ETS 300 174
pr A1

**This draft amendment A1, if approved, will modify
the European Telecommunication Standard ETS 300 174 (1992)**

Network Aspects (NA);
Digital coding of component television signals
for contribution quality applications
in the range 34 - 45 Mbit/s

Page 60, amendment to subclause 12.2.2, figure 23

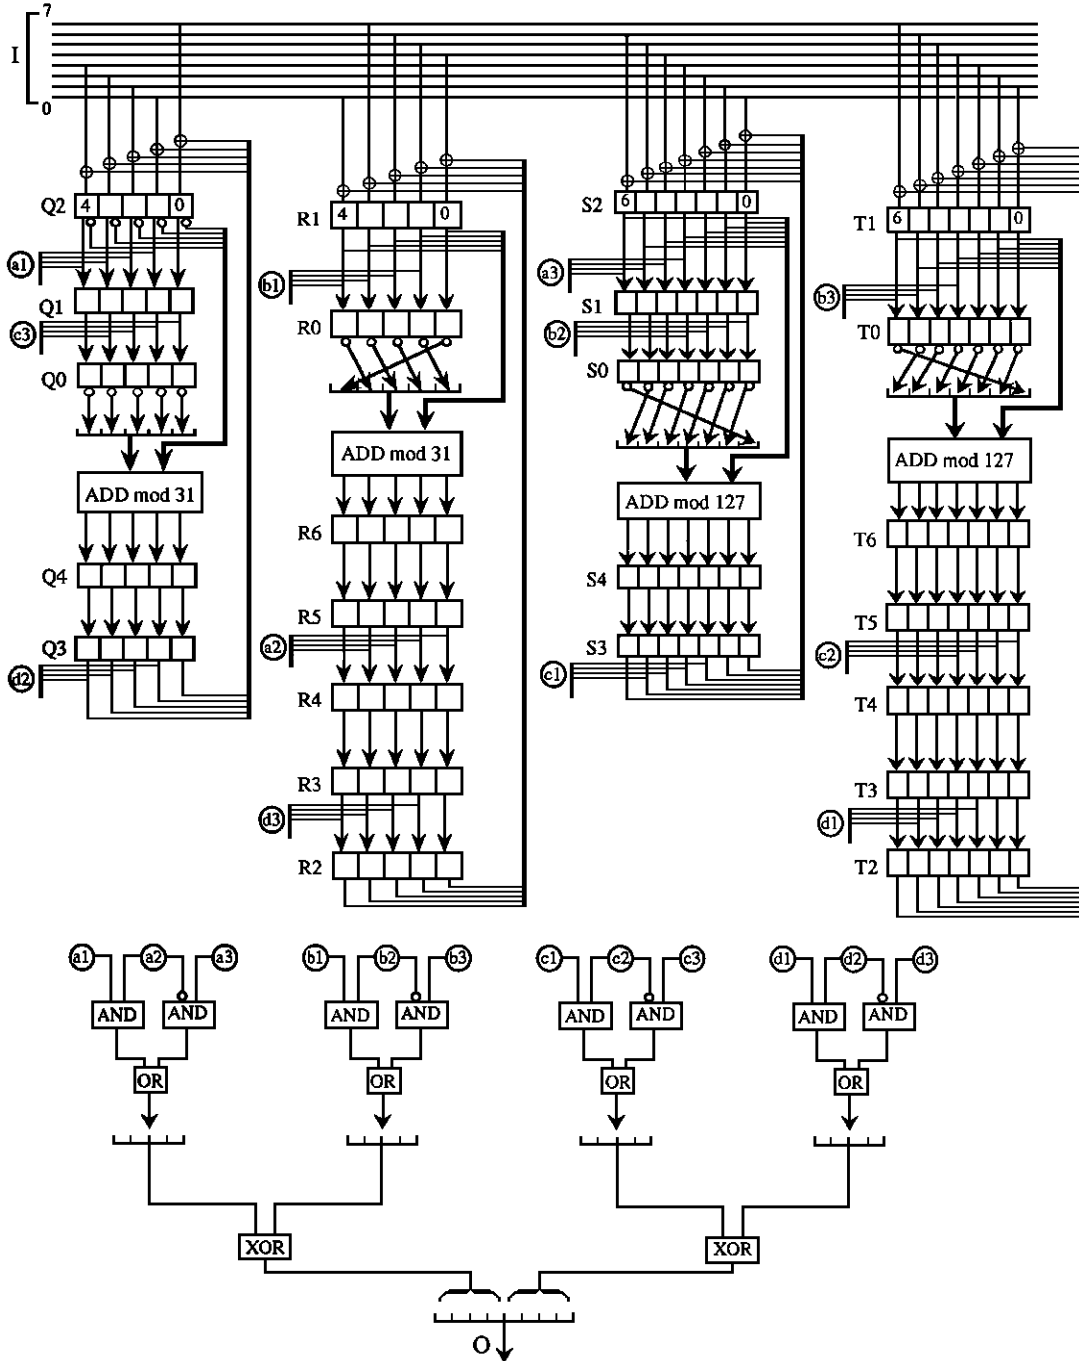
Replace figure 23 by:

Page 64, amendment to subclause 12.5

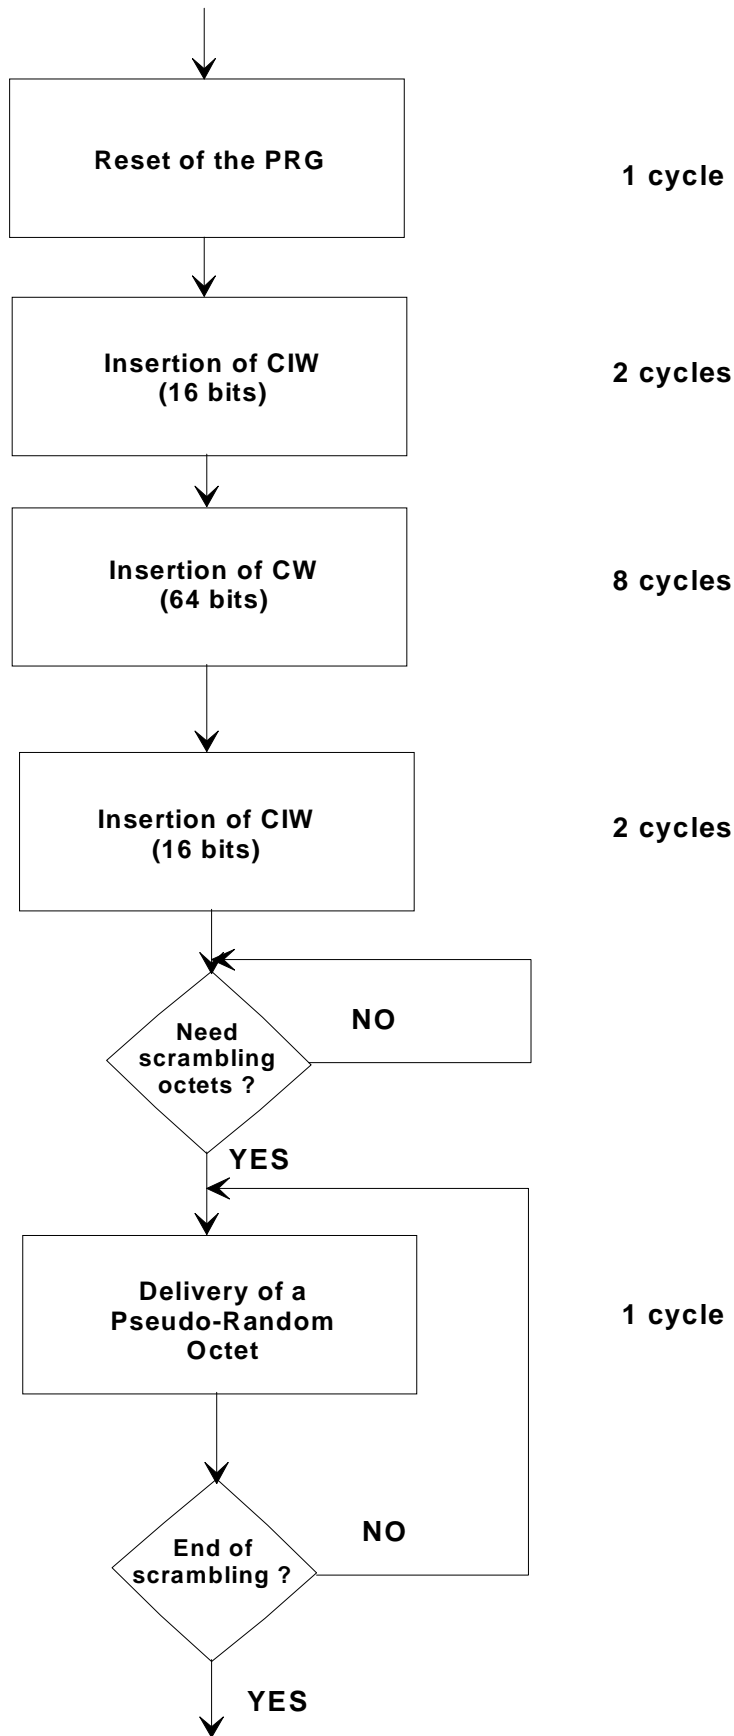
Replace the figure 26 by:
